## TECHNICAL NOTE # 223B

**Re: MicroPoint™ Cable MC115-220 and MC315-220**

**Date: April 13, 2012**

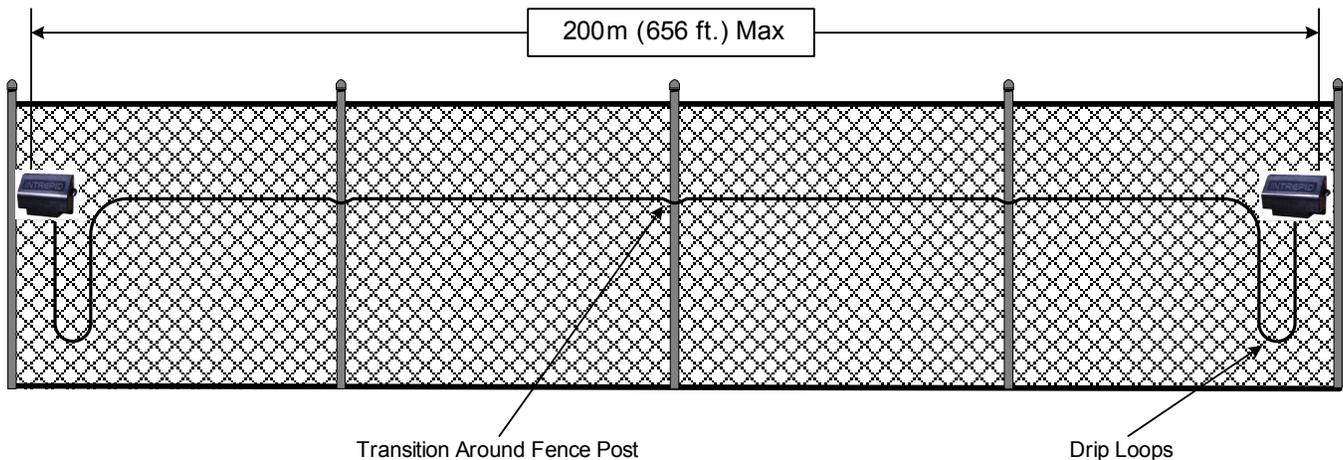
The MicroPoint™ cable MC115 and MC315 have been extended from 200m (656 ft.) to 220m (722 ft.). The increased length allows for full utilization of the 190 Subcells available in the Site Manager Software used to configure the systems. With the original length of cable, only 181 Subcells could be used. 181 Subcells calculates to 200m (656 ft.) of cable. 190 Subcells calculates to 209m (686 ft.) of cable.

The increased length now allows for linear spacing of the MicroPoint™ modules (PM, LU, ILU and TU) at 200m (656 ft.) as shown in the figure below. This provides the capability of having two (2) 100m (328 ft.) fence detection zones per cable. This was not capable with the MC115-200 or the MC315-200. With drip loops and transitions around fence post, the distance was always shorter.

**NOTE: The cable will not provide detection beyond Subcell 190 (209m). If the full roll of cable, 220m (722 ft.) is installed on the fence and then the modules attached, detection will not be beyond the 190 Subcell locations or the 209m (686 ft) length so the system will have no detection for the last 11 meters (36 feet). The remaining cable (11m) should be cut off to ensure proper operation. This cable can be used to repair damaged cable from cuts or physical damage with the use of Splice Units (SU).**
